Consultation

Peterborough Compressor Emissions – Re-opener Application

Publication date: 7 April 2026

Figure 1: Network Capability and 1-in-20 Demand Forecast (South West)

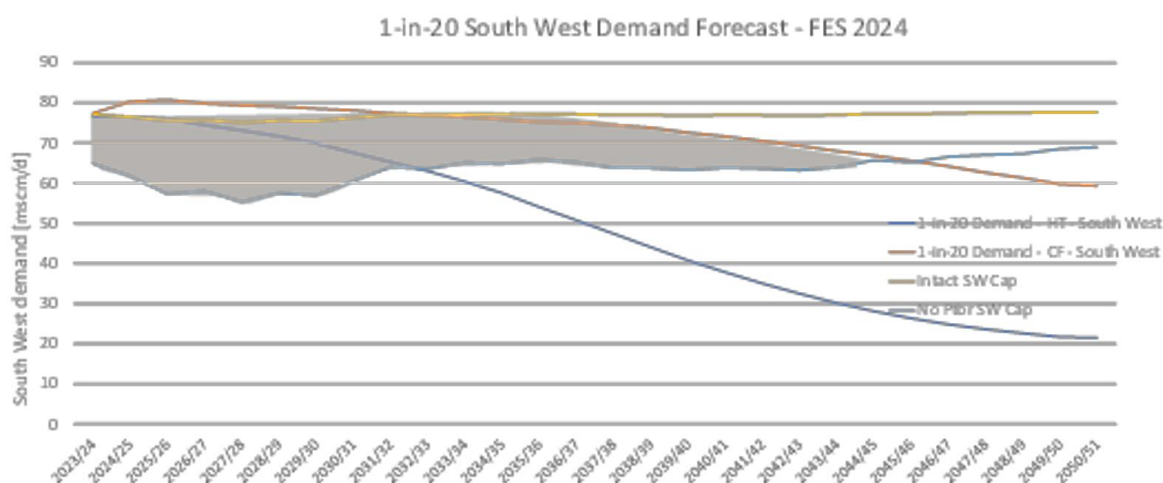
4.10 Figure 1 below indicates that meeting 1 in 20 peak day demand obligations (Standard Condition 16) in the south west will continue to require parallel operation at Peterborough Compressor Station until some point between the early 2030s (Holistic FES24 Scenario) and the mid 2040s (Counterfactual Scenario). For this reason, despite the poorer performance of the Final Preferred Option in the updated Cost Benefit Analysis we continue to reject the Counterfactual Option.
